**Subject:** TO CEP: Implications of cracked canisters [RETRY]

SUBJ: Implications of cracked canisters (and other emergencies).

San Onofre Nuclear Generating Station Exclusion Zone

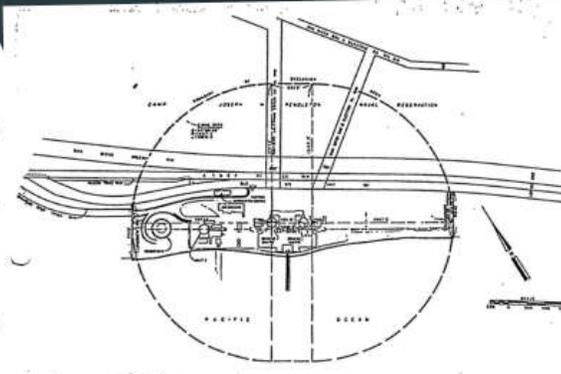
According to the San Onofre license, there is an exclusion area defined which encompasses a large section of the freeway, the frontage road, and the beach area which is easily accessible to the public. No signs exist informing the public that this is an exclusion area and concern for radiation to the public occurs at the boundary of this area.

The license also says that there must be a way to control traffic on the roads next to the plant but there is no control to this area of the freeway that I have seen. I would think they would have to install lights and gates at the previous overpass so cars can be easily stopped and turned away.

To make matters worse, the exclusion zone as calculated from a 1980s NRC document says the exclusion area should actually be more like 1km, which is about to the gates of the south state park and encompasses all of the popular beach area to the north. Unfortunately, SCE and San Onofre has violated the trust of the public by allowing the public to get very close to the plant. Again, the dose calcs ASSUME no one is in the exclusion area and a member of the public is NO CLOSER than the exclusion area. So those dose calcs are optimistically too low.
